Appendix I of  
MPC Paper No. A/K14/797A

**Section 16 Planning Application for Proposed Non-domestic Facilities  
and Minor Relaxation of Plot Ratios and Building Height  
Restrictions for the Proposed Public Housing Developments at  
Anderson Road Quarry Sites R2-5 and R2-8, Sai Kung**

**Section 16 Planning Application for Proposed Non-domestic Facilities and Minor Relaxation of Plot Ratios and Building Height Restrictions for the Proposed Public Housing Developments at Anderson Road Quarry Sites R2-5 and R2-8, Sai Kung**  
(Application no. A/K14/797)

**Response-to-Comments from Urban Design and Landscape Section of Planning Department dated 18 January 2021**

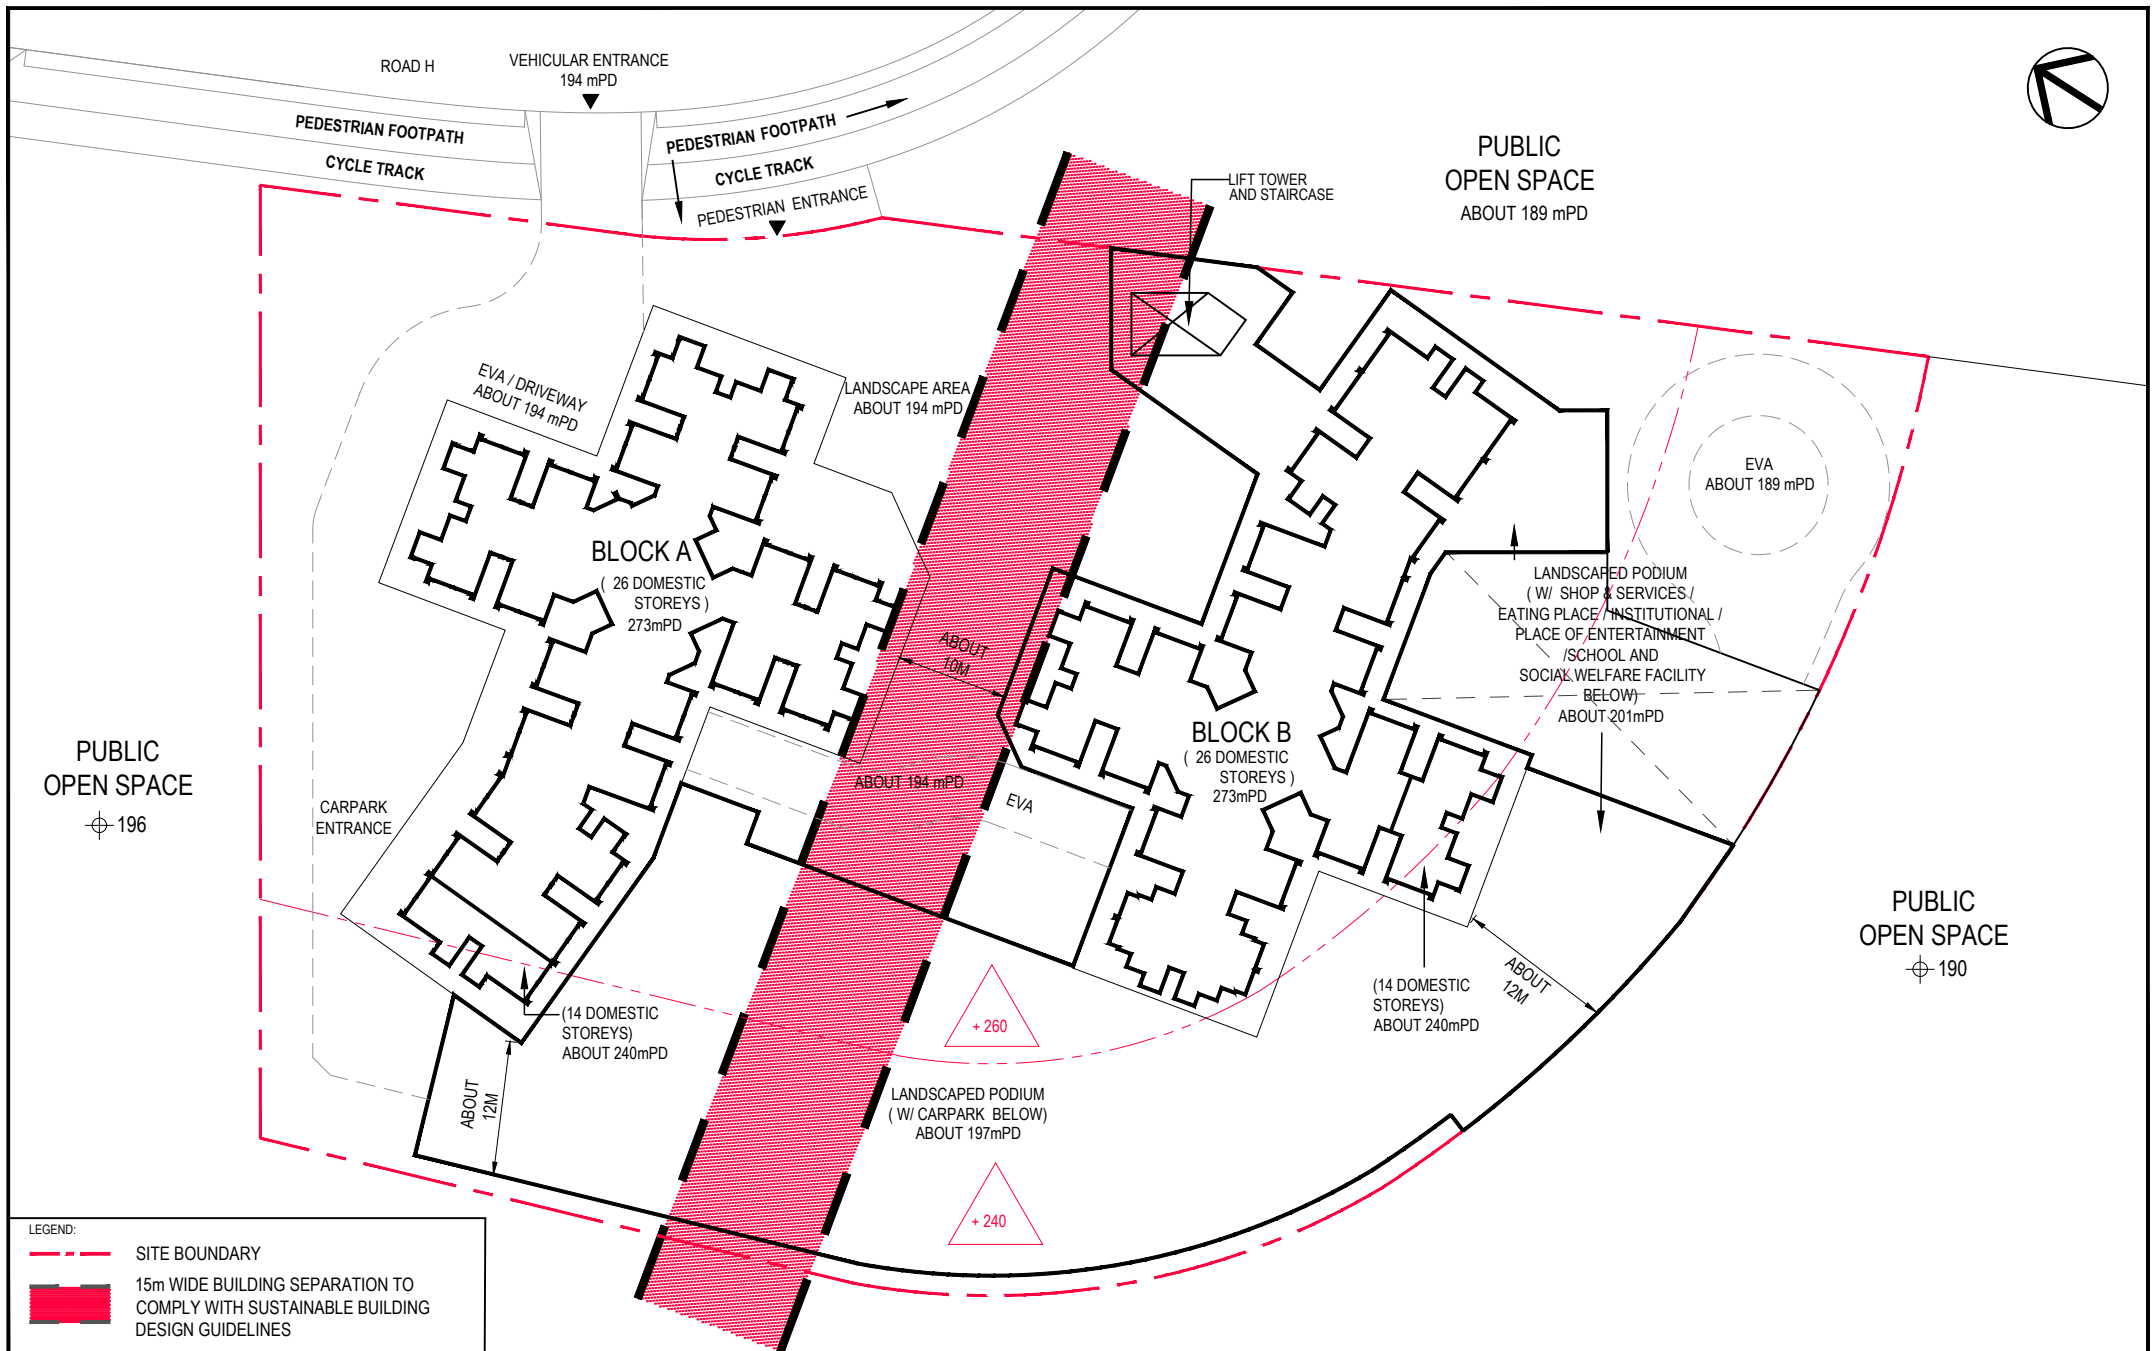
Date	Department	Department's Comments	HD's Response
		<p>proposed domestic blocks have adopted a stepping design, which is in general respecting the intended stepped height profile for the sites. Accommodation of the proposed development would unlikely cause any significant adverse visual impact.</p> <p>4. With reference to the master layout plan and landscape master plan provided, some landscape treatments (e.g. landscape area and periphery planting) and design features (e.g. children play area and badminton court) will be incorporated at the lower levels of the proposed development at both sites.</p> <p>5. As to the additional PR, it is intended for accommodating the additional non-domestic facilities to serve the community. We have generally no comments on this aspect from urban design and visual perspectives.</p> <p>6. Notwithstanding, the applicant might wish to note the following minor comments:</p> <ul style="list-style-type: none"> <li>• <b>Para. 4.4 Bullet Point 1</b> – it is noted that a 15m separation/building gap between the domestic blocks at Site R2-5 will be proposed. Please consider indicating such building gap on the relevant plan(s).</li> </ul>	<p>Noted.</p> <p>Noted.</p> <p>Noted. The 15m separation/building gap has been incorporated. Please find enclosed revised Figure 5 of the VIA.</p>
